**RESOLUTION MEPC.81(43)
adopted on 1 July 1999**

**AMENDMENTS TO SECTION 9 OF THE STANDARD FORMAT FOR
THE COW MANUAL (RESOLUTION MEPC.3(XII))**

**AMENDMENTS TO SECTION 9 OF THE STANDARD FORMAT FOR
THE COW MANUAL (RESOLUTION MEPC.3(XII))**

**"SECTION 9: DETERMINATION OF THE SUITABILITY OF A CRUDE OIL FOR
USE IN CRUDE OIL WASHING"**

Figure 1: Four Point Temp
Dog C

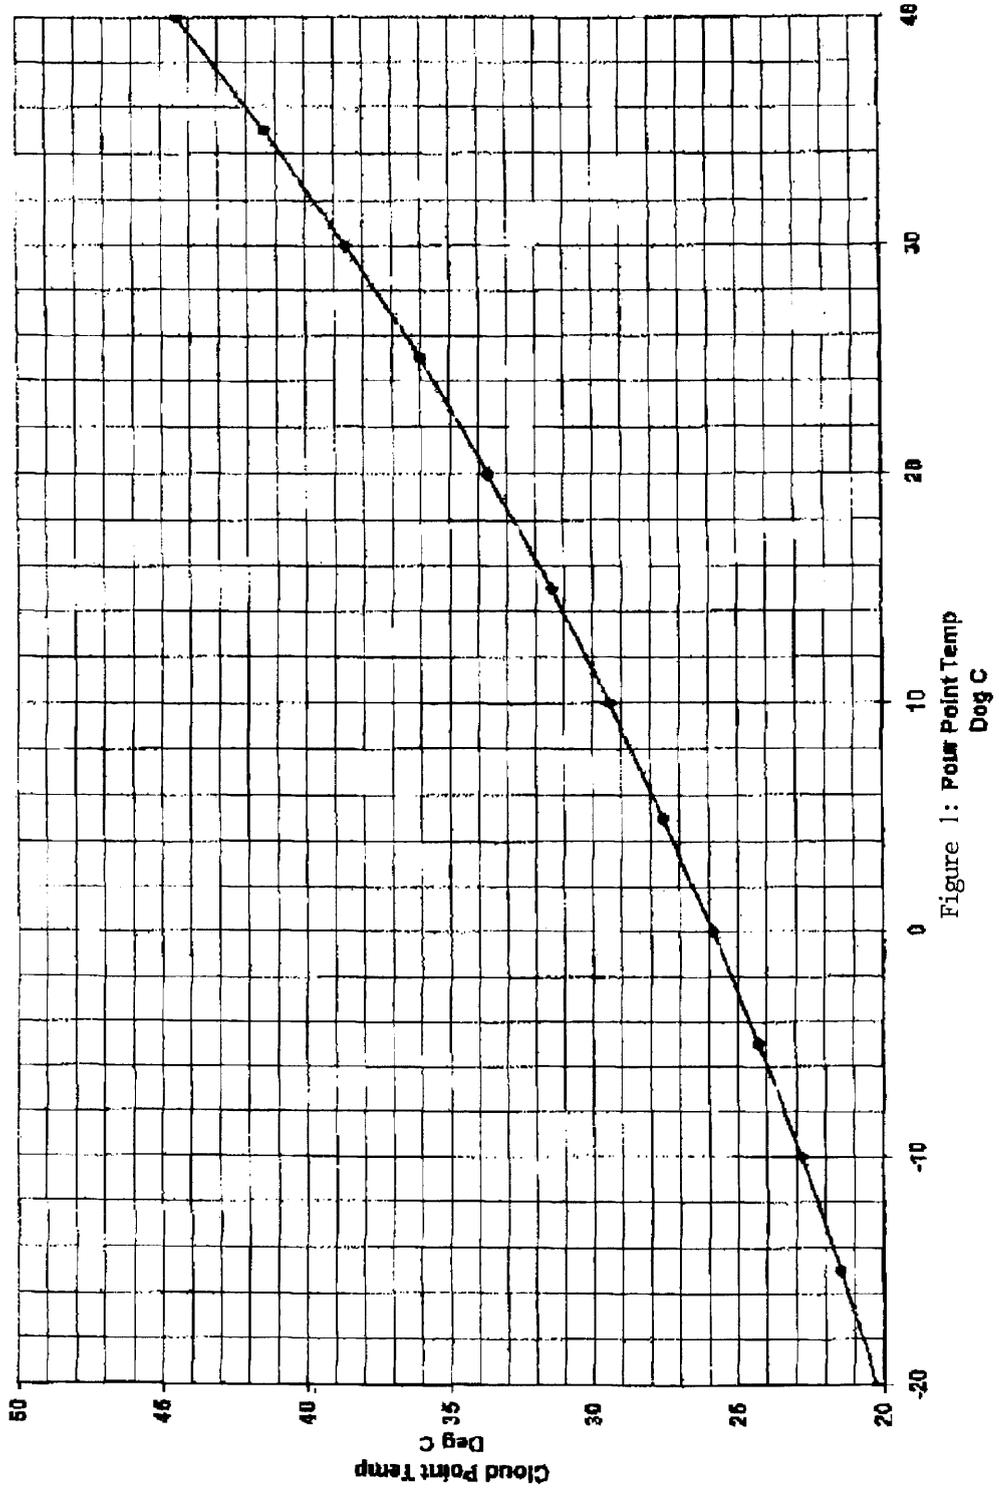
Consult the accompanying graph, (*Fig 1*) where if the Pour Point is known then the Cloud Point can be extracted.

Figure 2: Time in Minutes

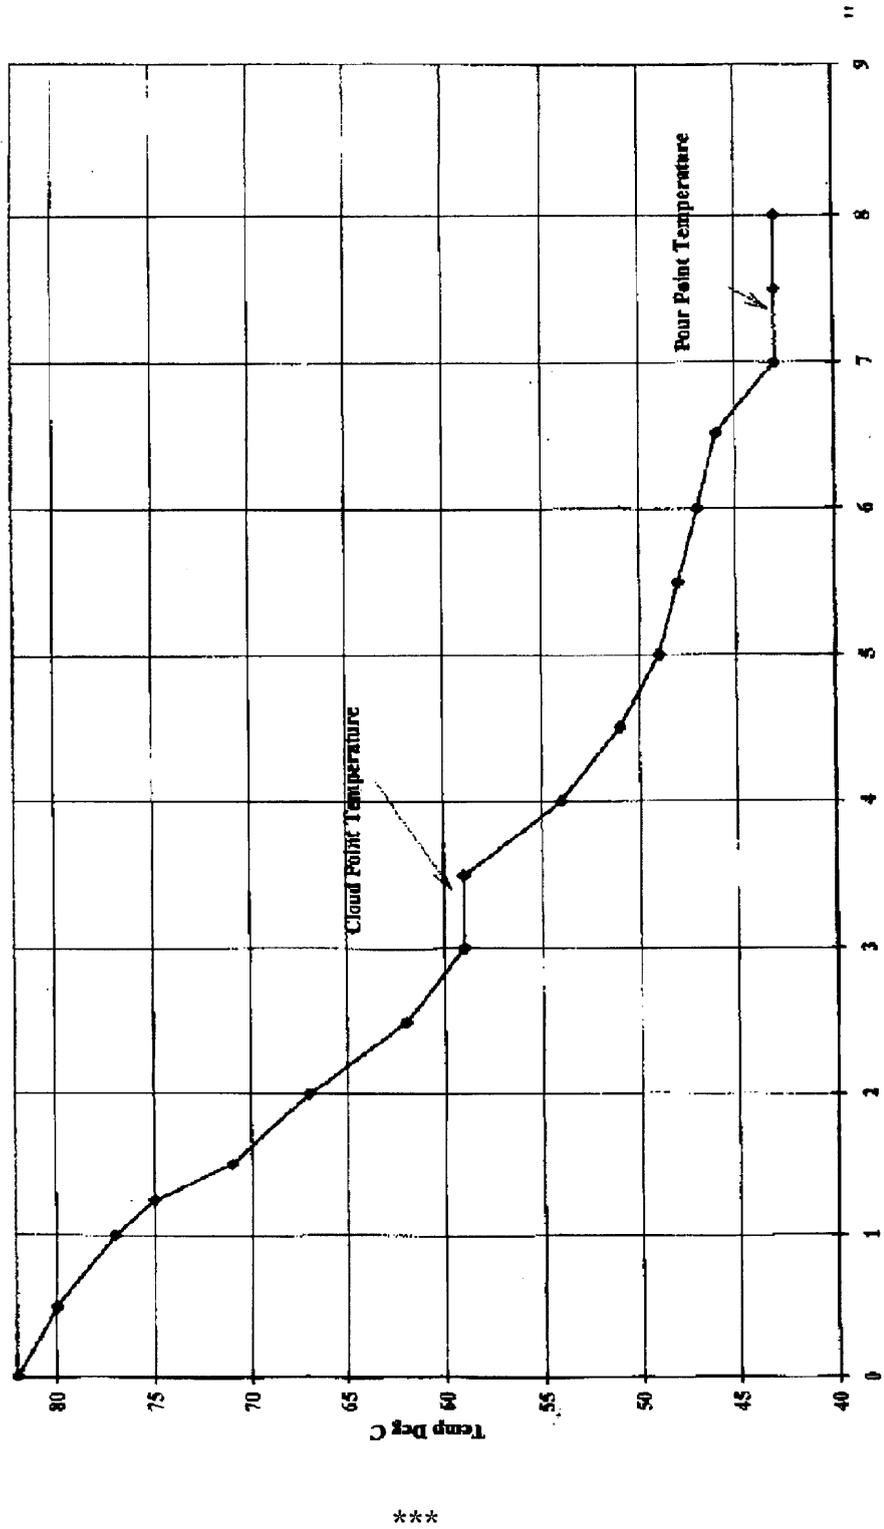
The Bondi Test Procedure (See Fig 2)

- (6) Graphically plot the sample temperature against time elapse from the start of the test. Determine the temperatures at which there was no loss of temperature with time elapse. The first such instance as detected will be the approximate Cloud Point temperature and the second instance, if testing time is extended to the required period, will be the approximate pour point temperature of the crude oil.
